[Docket No. FAA-2016-9418; Product Identifier 2016-NE-23-AD; Amendment 39-19167; AD 2018-02-14]

Airworthiness Directives; Honeywell International Inc. Turboprop and Turboshift Engines

ACTION: Final rule.

Figure 1 to Paragraph (h) of this AD. Combustion Chamber Case Assembly Without the One-Piece Bleed Pad with P3 Boss

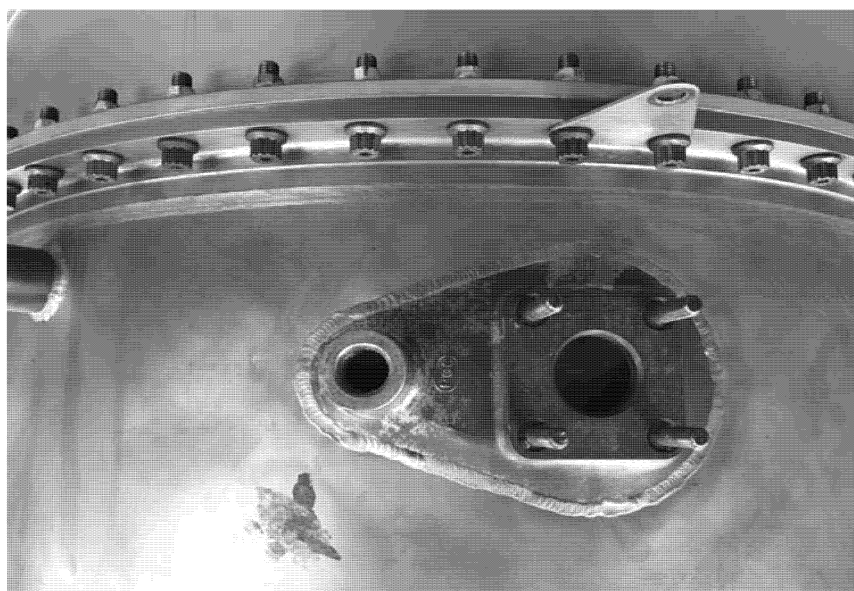
TPE331 model engines modified by STC SE383CH may be defined as the “Super 1” and “Super 2” for the compressor modification of the TPE331–1 and the TPE331–2, –2U, and –2UA engines, respectively. Figures 1 and 2 to paragraph (h) of this AD illustrate the appearance of combustion chamber case assembly, P/N

893973-5, without and with, respectively, the one-piece bleed pad with the P3 boss.

After the effective date of this AD, do not install a combustion chamber case assembly,

P/N 869728-1, 869728-3, or 893973-5, in TPE331-3U, -3UW, -5, -5A, -5AB, -5B, -6, and -6A engines or in TPE331-1, -2, and -2UA engines modified by National Flight

Services, Inc., STC SE383CH, unless the combustion chamber case assembly has a one-piece bleed pad with P3 boss.
